RELAYS
286, 287, AND 288 TYPES
PIECE-PART DATA AND REPLACEMENT PROCEDURES

1.001 This addendum supplements Section 040-272-801, Issue 5.

1.002 This addendum is issued to revise 1.11 which covers the new material for the P-19A162 cover, to revise Fig. 1, and to replace the P long-nose pliers with the B long-nose pliers.

Fig. 1—286-Type Relay

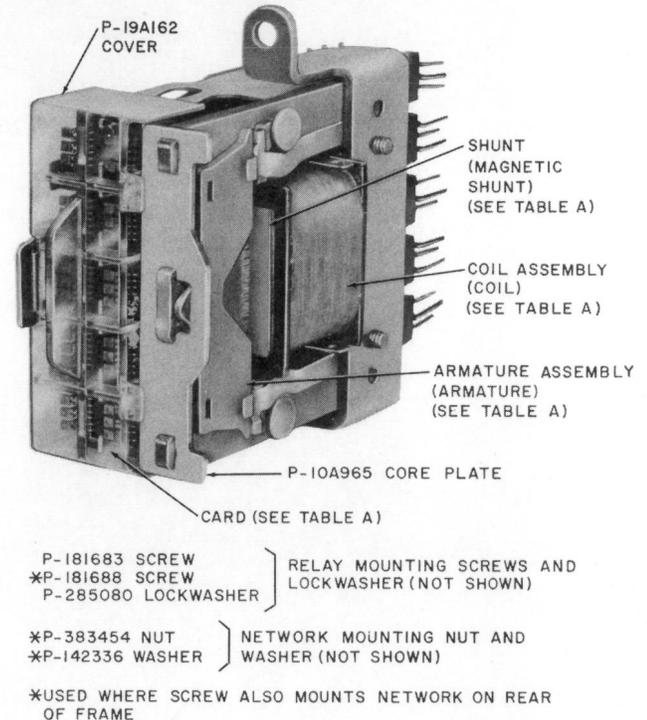
(a) Current Fig. 1 is replaced by the following Fig. 1 which had the callout for the P-10A965 core plate corrected.
